DS-K1T342 Series MinMoe Release Notes
(2026-2-4)

| Device Model:

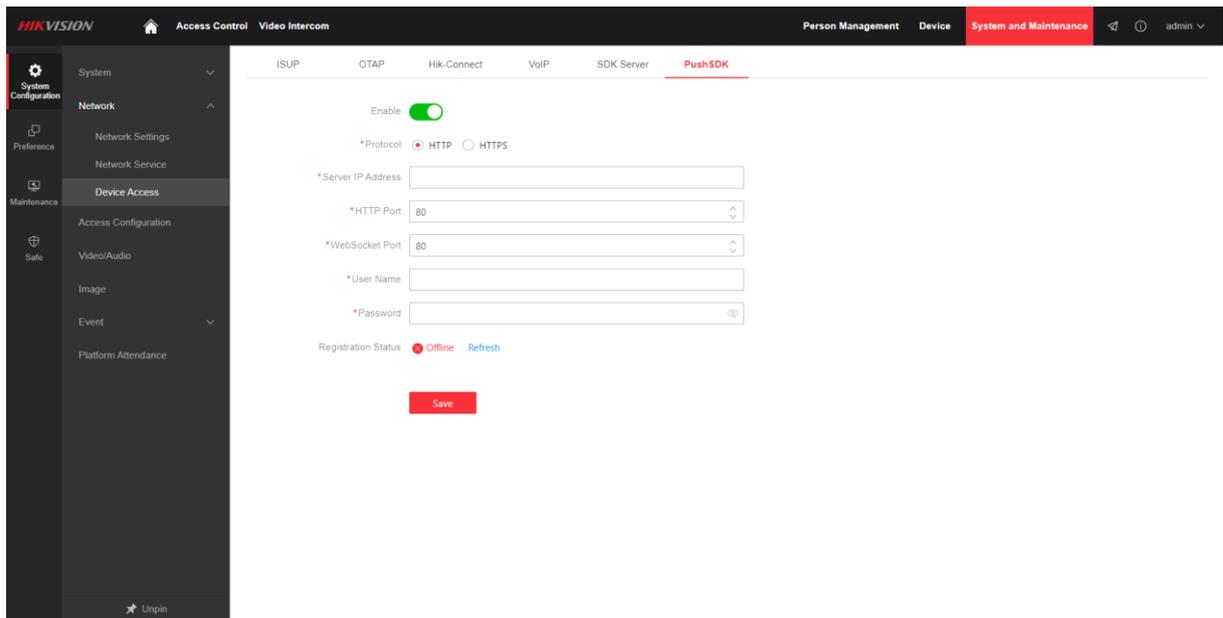
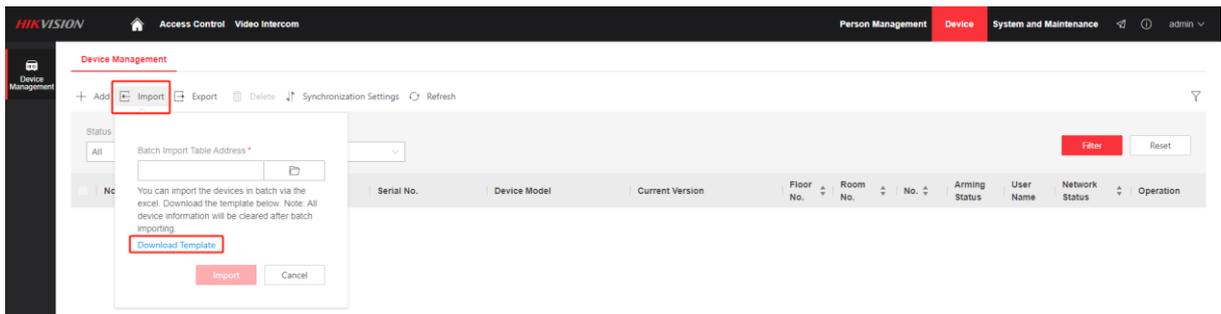
1. Support push SDK

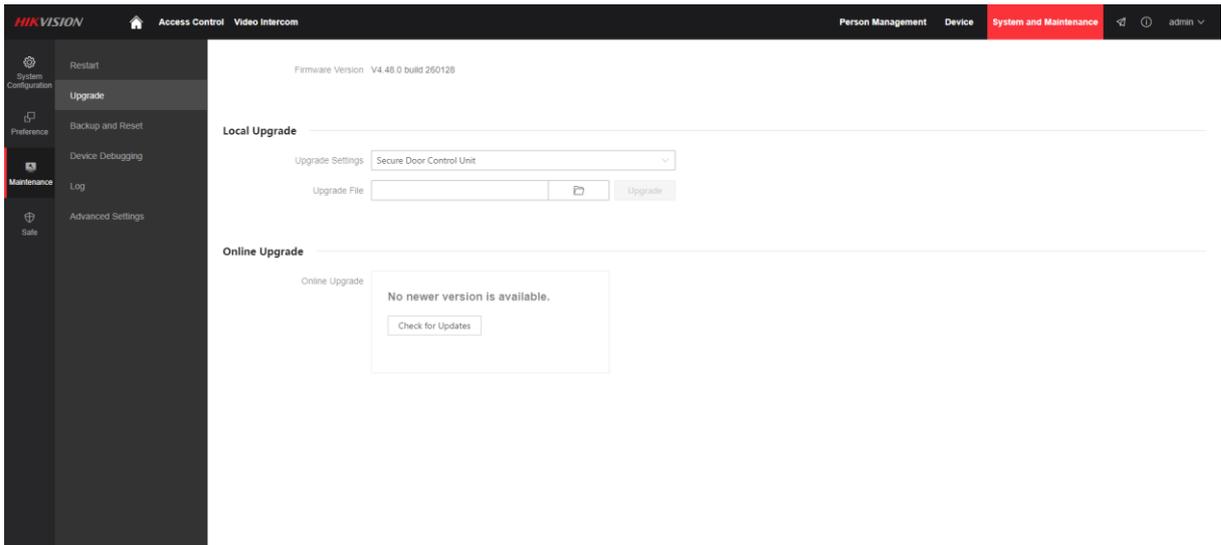
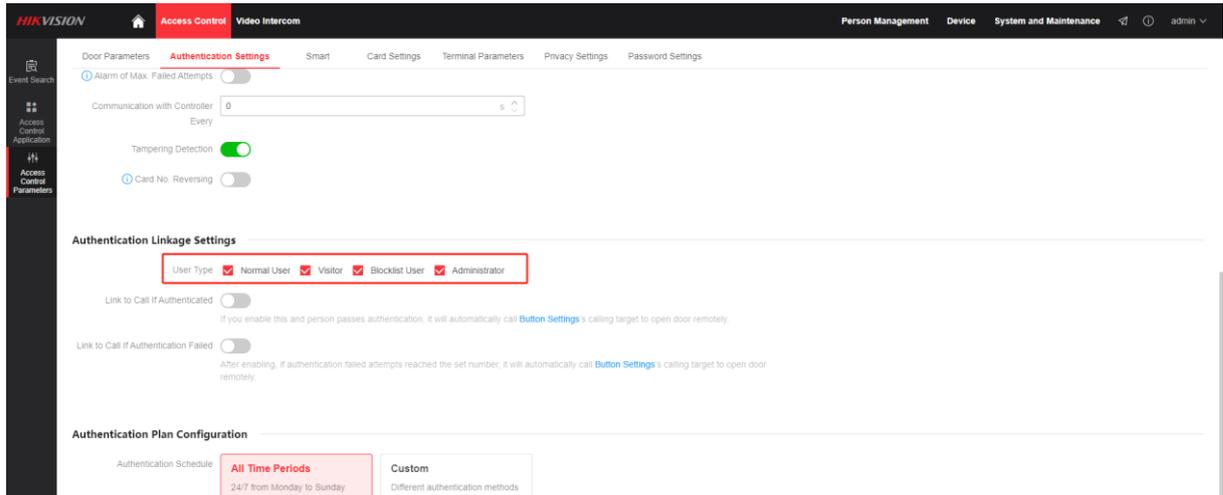
2. Support to upgrade "Secure Door Control Unit" in web page

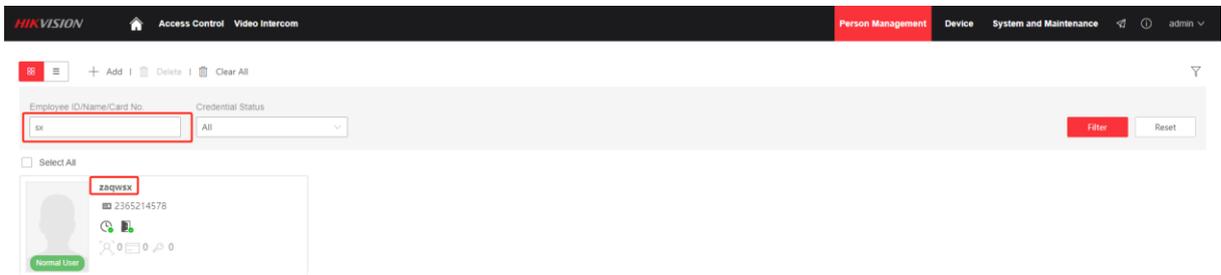
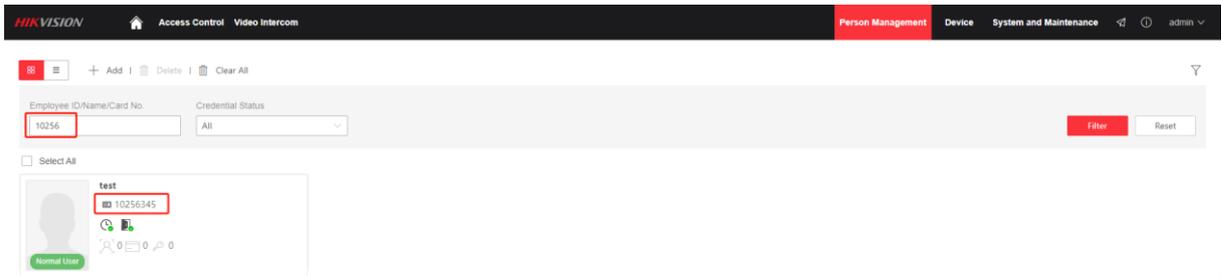
3. Support fuzzy search by personnel ID or name in web page

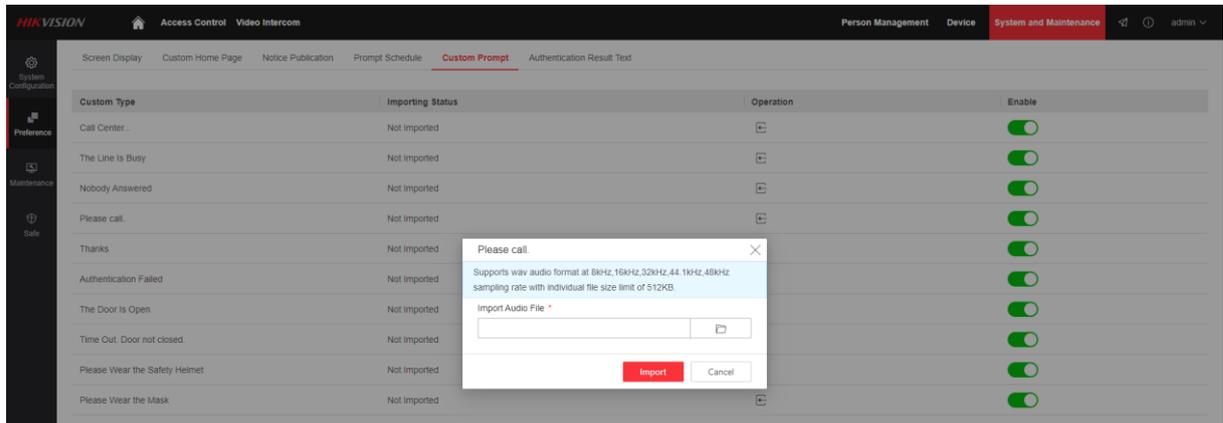
6. Support to verify audio sampling rate when importing audio files

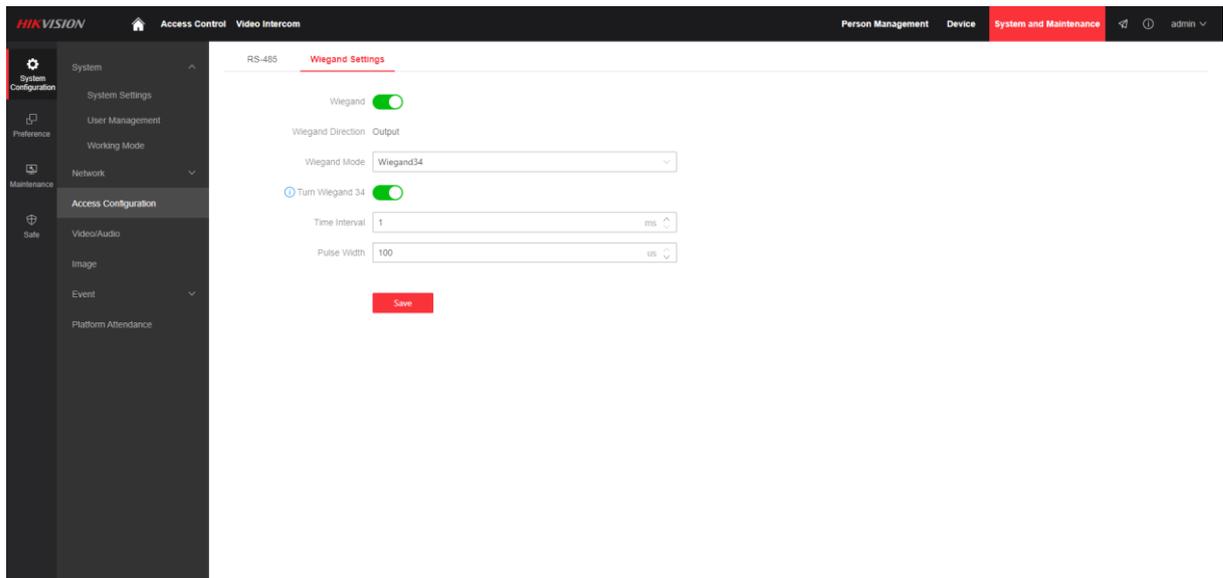
8. Support to directly export events from web page and view it

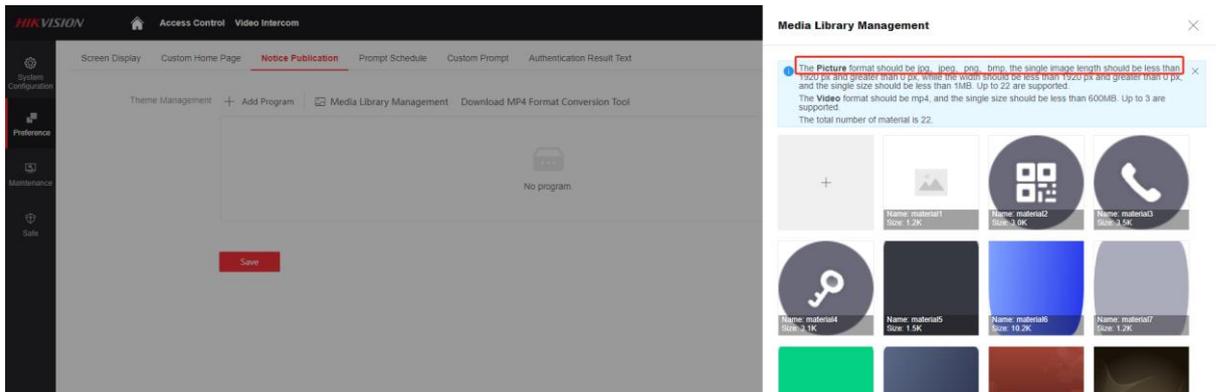
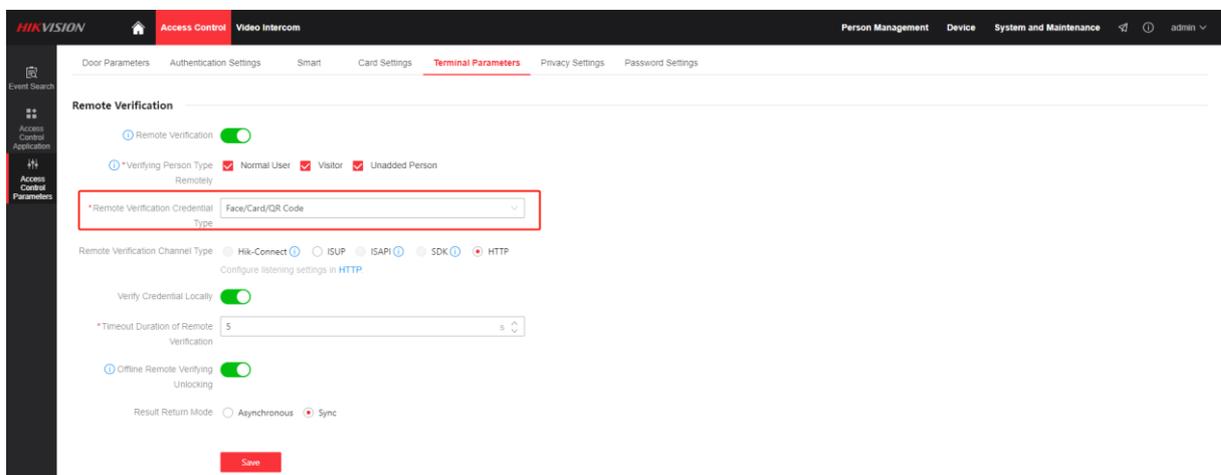
10. Add new picture formats: .jpg, .png and .bmp

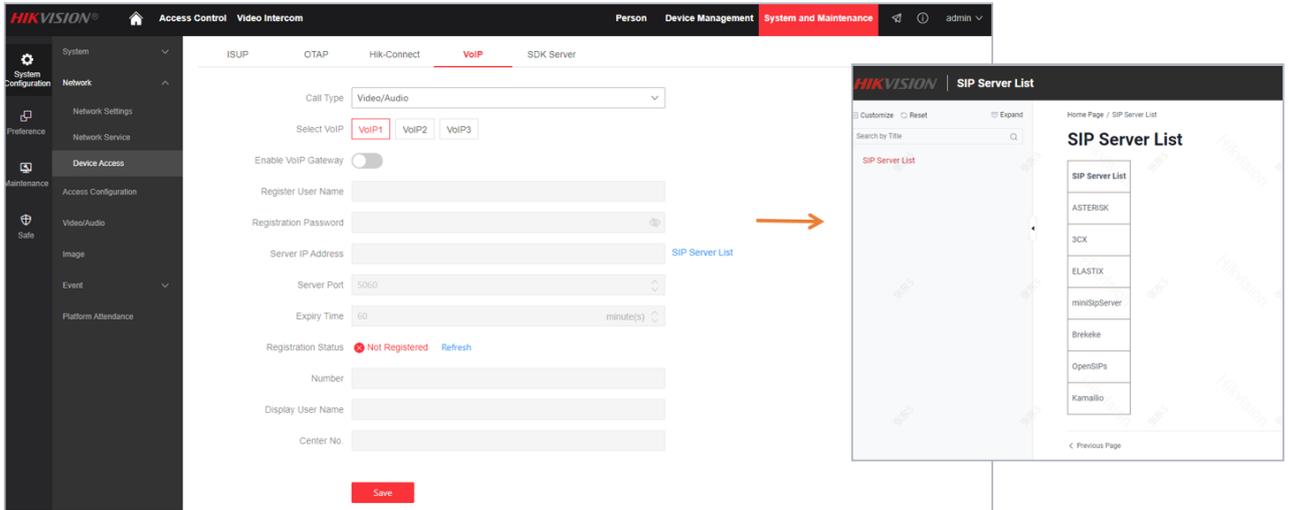
- **Video intercom**
1. Supports preview before answering for VoIP
2. In the remote door opening event of a SIP call, the room number can be uploaded
3. Support the door station being called

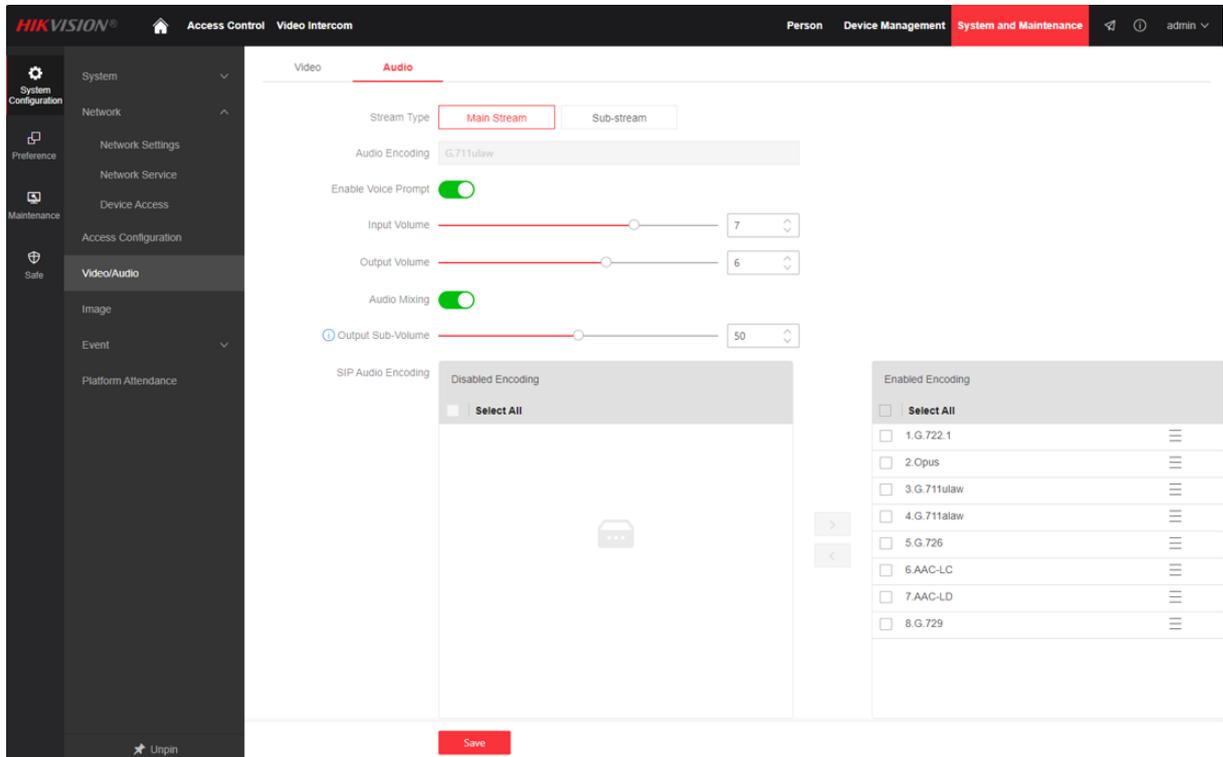
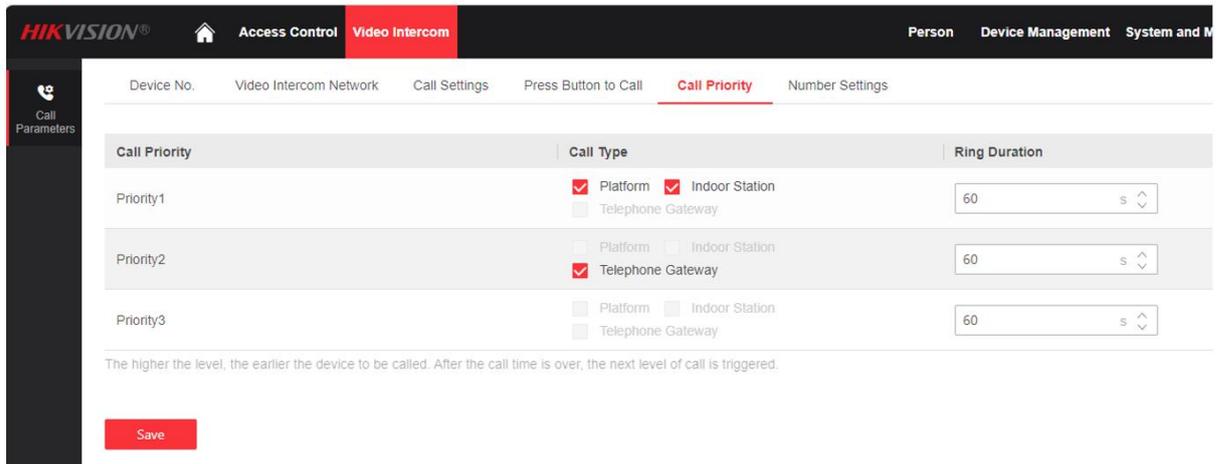
4. Optimized intercom audio encoding capabilities, improving audio sampling rate

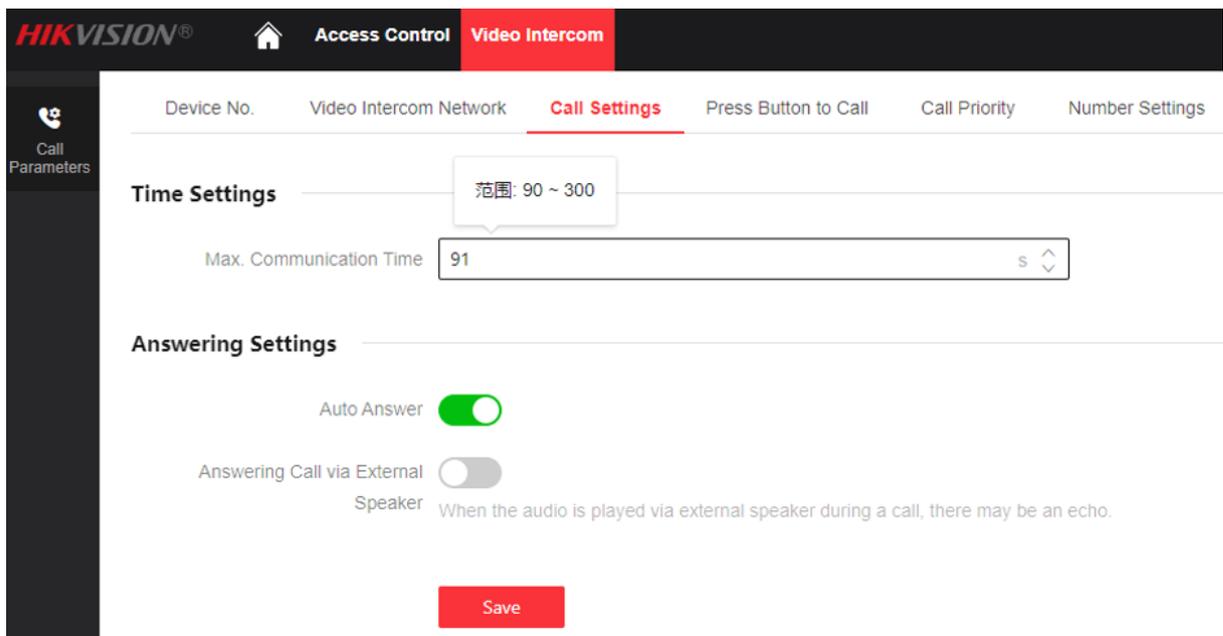
5. Modify the maximum call duration for intercom form 180 to 300

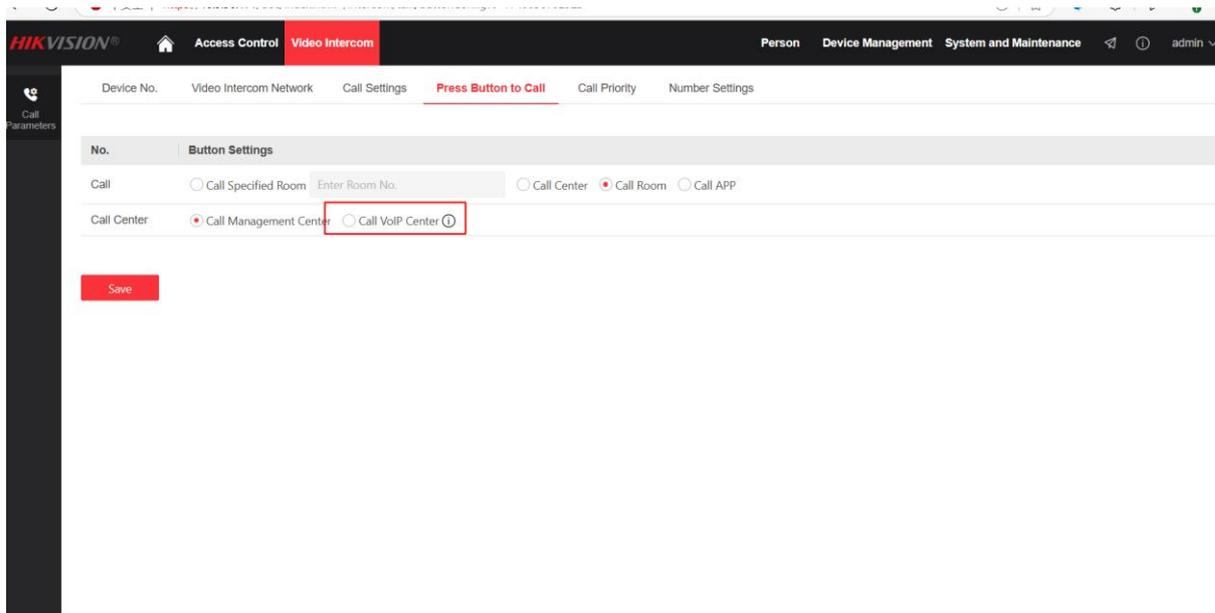
8. Support returning to the home page during a call on the screen
9. Support returning to the call interface after a call timeout
10. Support automatic dialing from the dialing interface
11. Support one-click call to the VoIP center

Remark: Added VoIP center as call center. When you push calling center button, the VoIP center will be called.

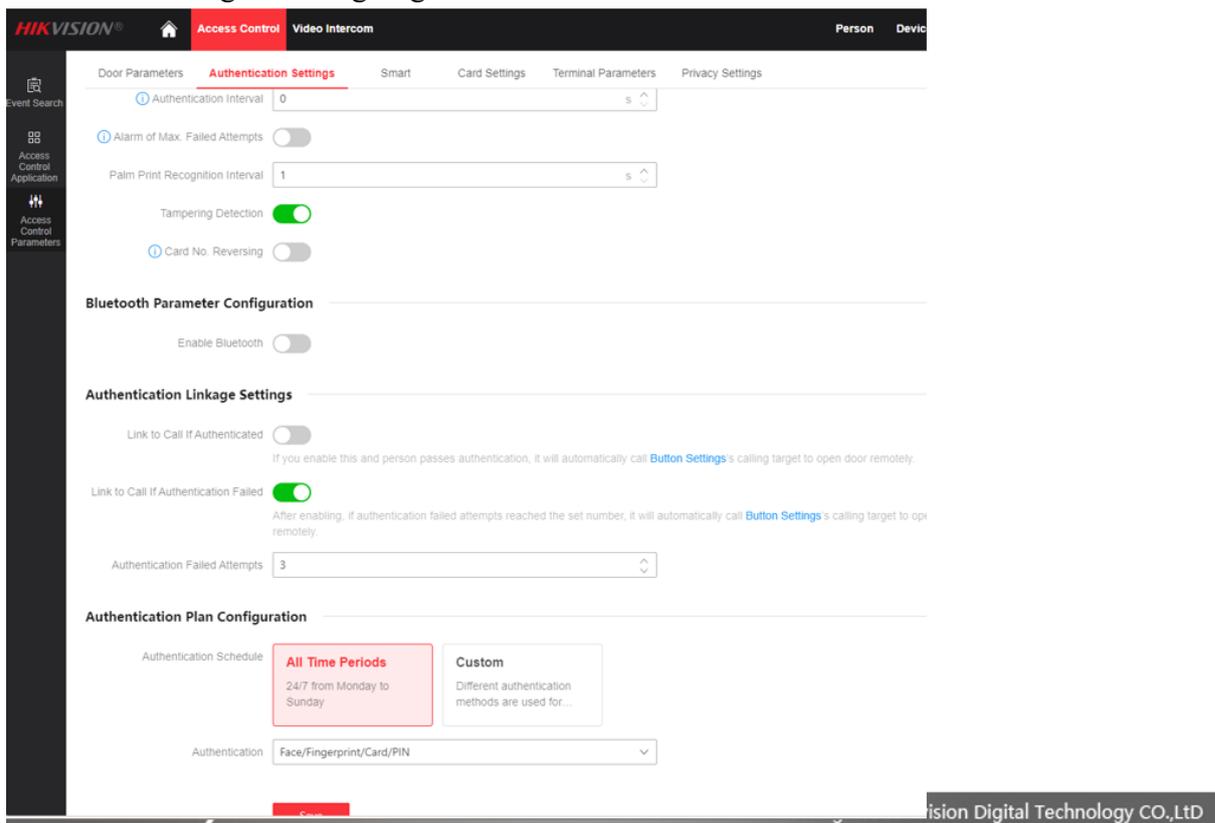
12. Support linkage calls for authentication failure

Remark: if authentication failed attempts reached the set number, it will automatically call button settings's calling target.
